INFORMATION SHEET 3/8/16 TRUSTEES MEETING

ISSUE: RGM Associates Jefferson Change Order #'s 114 & 073r1

Traina Gymnasium Change Order #'s 039r1, 042, & 043

JEFFERSON SCHOOL REPLACEMENT
INCREMENT #1

BUILDING "A"
FIRE SPRINKLER
PIPING PLAN

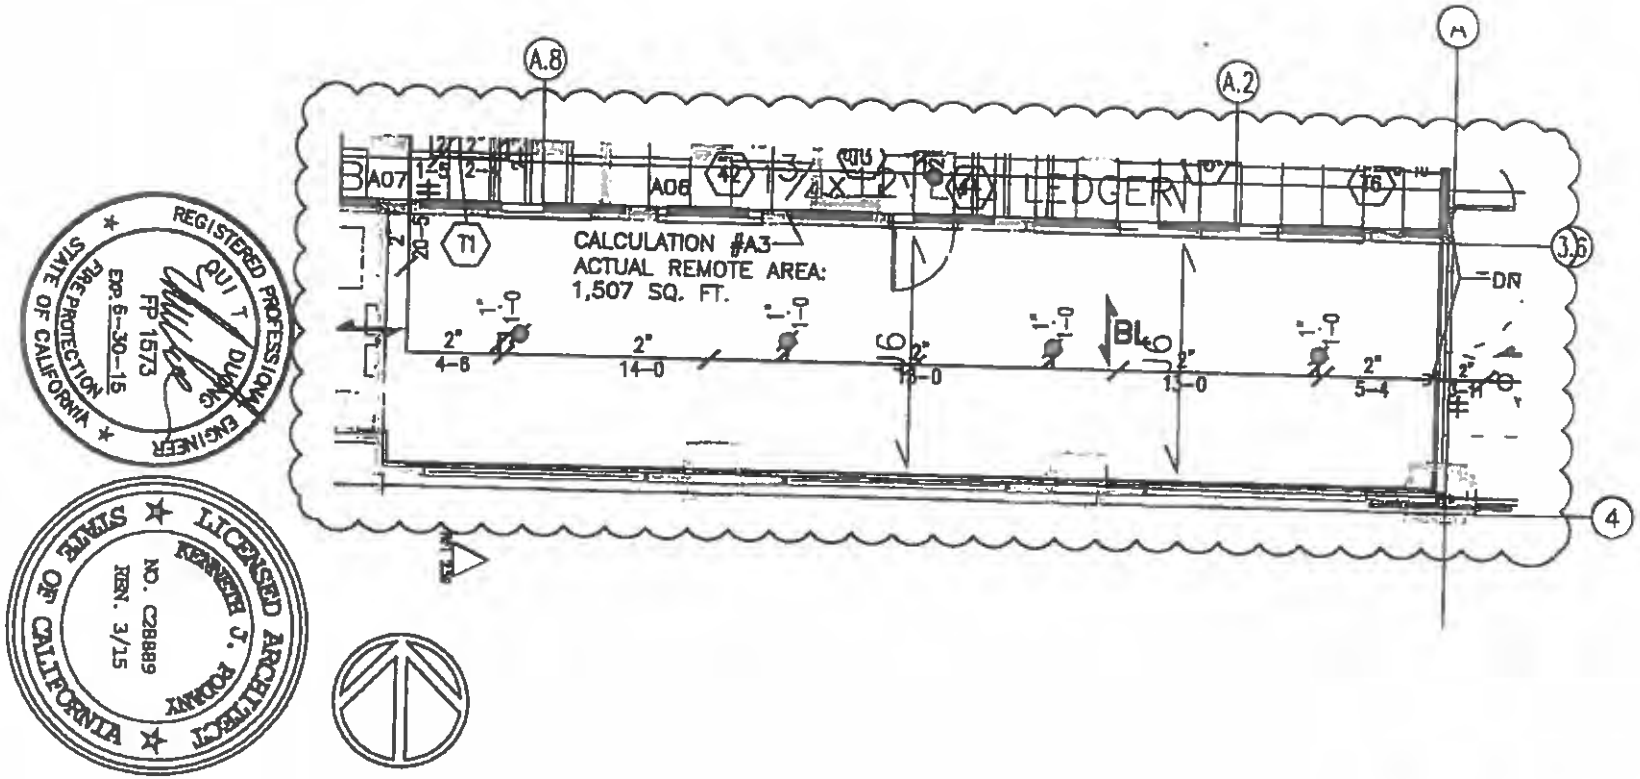
1.) Area between Grid "3.6" & Grid line "4", between Grid line "A" & "B", south exterior walkway coverage.

The attic above the exterior walkway has no room for piping to be installed as shown on project plan page "FP-2.1.

Please advise.

Response:
Sprinkler pipes shall be installed as shown in plans. Refer to detail 4/S-5.5 for typical boring of joists.

Additional Response Upright sprinklers at the front soffit at building A may be omitted as shown on attached sketch and code references Provide a credit for the removal of these heads
